पत्रांक— 2612 /12-1 देहरादून :दिनांक: 29 अप्रैल, 2025

**विषय :-** उत्तराखण्ड राज्य में राष्ट्रीय राजमार्ग संख्या-72 (झाझरा के पास) को दिल्ली-देहरादून एक्सप्रेस वे (आशारोड़ी सेक्शन के पास) से जोड़ने वाले चार लेन ग्रीनफील्ड रोड का विकास किमी0 0.050 से किमी 12.220 तक निर्माण हेतु 20.0849 है0 वन भूमि का गैर वानिकी कार्यों हेतु भारतीय राष्ट्रीय राजमार्ग प्राधिकरण को प्रत्यावर्तन। (Online Proposal No.- FP/UK/ROAD/140350/2021)

**Project Name-** Development of 4-lane Greenfield road connecting NH-7 (old NH-72) (near Jhajhra) to Delhi-Dehradun Expressway NH-307 (old NH-72A) at Asharori Section from Km. 0.000 to Km. 12.000 in the State of Uttarakhand.

Sl. No.	Conditions	Reply
1.	The DFO Dehradun and Project Proponent shall submit a technical specification and details of attempts made to reduce the felling of trees and findings thereof.	<p>In forest area, a ROW of only 30 m has been proposed in most of length. The top width for a 4-lane divided highway with a minimum 2.5 m of median works out to be 23.5 m in plain and rolling terrain. The ground is not exactly flat and is undulating in which cutting and fills are required in most of length. Even if 1 m toe line is filled, the total width r

**PLAN**  
**For**  
**Wall fencing around the forest land**  
**adjacent to the Proposed 4-Lane**  
**Greenfield Road from NH-7 (Jhajhra) to**  
**NH-307 (Asharori) to avoid any**  
**encroachment and protect forest form**  
**collateral damage**

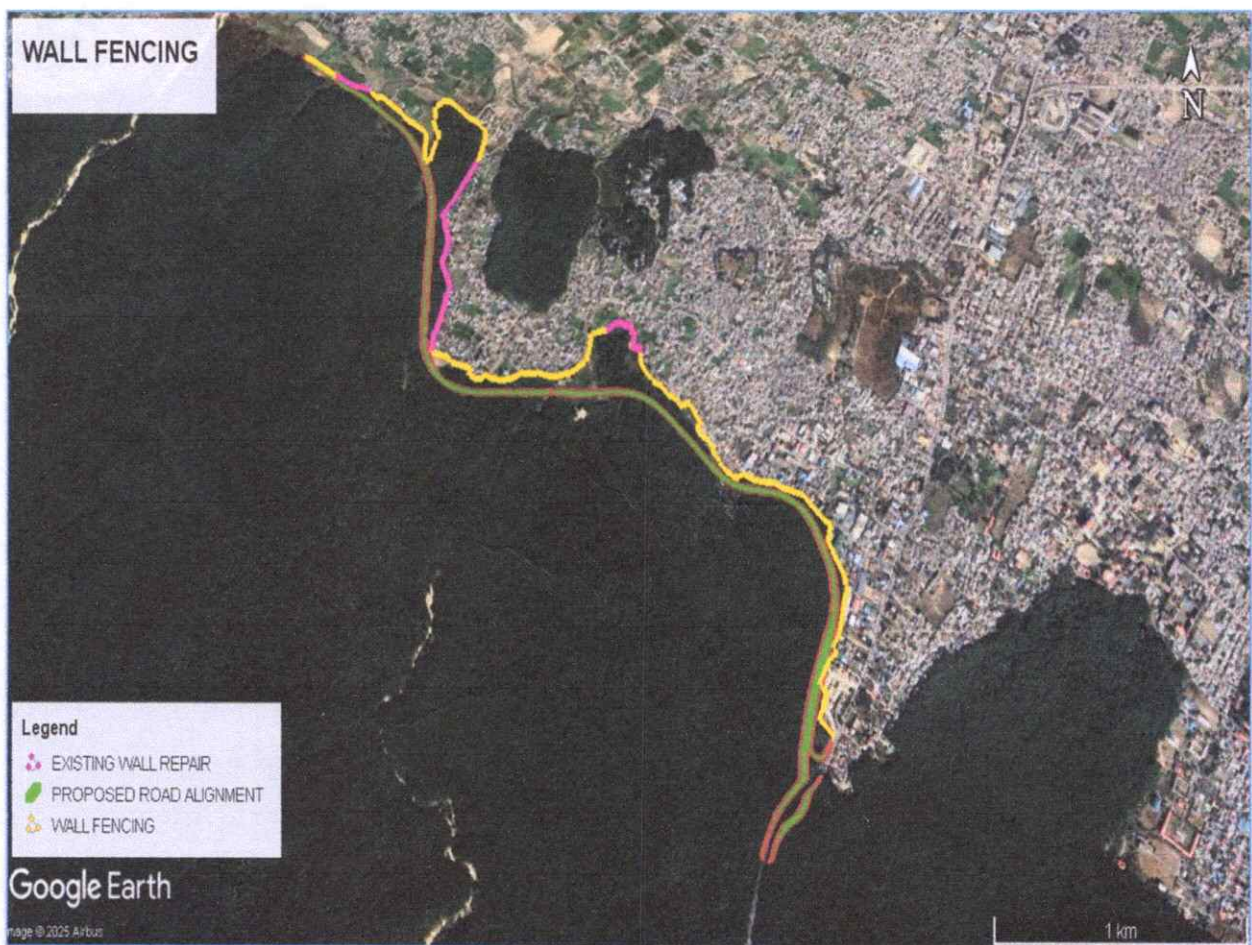
3	The DFO Dehradun shall prepare a plan for fencing (wall fencing) around the forest land adjacent to the proposed road to avoid any encroachment and protect forest land from collateral damage. The cost of the proposed wall shall be borne by the user agency.	बिन्दु सं0-3 के अनुपालन में प्रस्तावित मोटर मार्ग एवं आबादी के बीच के वन क्षेत्र को भविष्य में अतिक्रमण से बचाने हेतु दीवार निर्माण की योजना संलग्न है। दीवार निर्माण का व्यय प्रयोक्ता एजेंसी द्वारा वहन किया जायेगा, जिसके सम्बन्ध में प्रयोक्ता एजेंसी द्वारा वचनबद्धता प्रमाण-पत्र उपलब्ध कराया गया है।
4	The DFO Dehradun shall prepare a plan for fencing (wall fencing) in the patches of adjacent forest lands inside the residential area that are prone to encroached in future. The cost shall be borne by the user agency.	बिन्दु सं0-4 के अनुपालन में प्रयोक्ता एजेंसी द्वारा वचनबद्धता प्रमाण-पत्र संलग्न किया गया है। वर्तमान में WII द्वारा उनके नियंत्रणाधीन वन क्षेत्र के चारो ओर फेन्सिंग कार्य कराया जा रहा है। इस विषय में इस कार्यालय के पत्र संख्या-6297/12-1, दिनांक 02.04.2025 (छायाप्रति संलग्न) से विस्तृत विवरण हेतु सूचना मांगी गयी है। तदनुसार ही अग्रेत्तर कार्यवाही करते हुए सूचना उपलब्ध करायी जायेगी।

3.	The DFO Dehradun shall prepare a plan for fencing (wall fencing) around the forest land adjacent to the proposed road to avoid any encroachment and protect forest land from collateral damage. The cost of the proposed wall shall be borne by the user agency.	Reply to be submitted by DFO. Draft undertaking is attached.

This spatial arrangement poses a strong risk of future encroachment, unauthorized land use, and degradation of these isolated forest areas. To address this risk, a new brick wall of **5962 meters** and repair of **250 meters** of existing wall are proposed to act as physical boundaries for the protection of the forest land. The construction of this wall will ensure the long-term conservation of forest ecosystems and prevent encroachment activities in these vulnerable areas. This plan aligns with directive from the MoEF&CC's REC meeting and the cost of the proposed wall shall be borne by National Highway Authority of India (NHAI).

Construction of 5962 meters of new brick boundary wall and Repair of 250 meters of existing damaged wall:

- Wall height: **1.50 meters above ground**
- Foundation depth: **0.5 meters with 0.10 m PCC base**
- 230 mm thick brick masonry in cement mortar 1:3
- 15 mm cement plaster
- RCC Column Placed at regular intervals for structural support and resists lateral forces
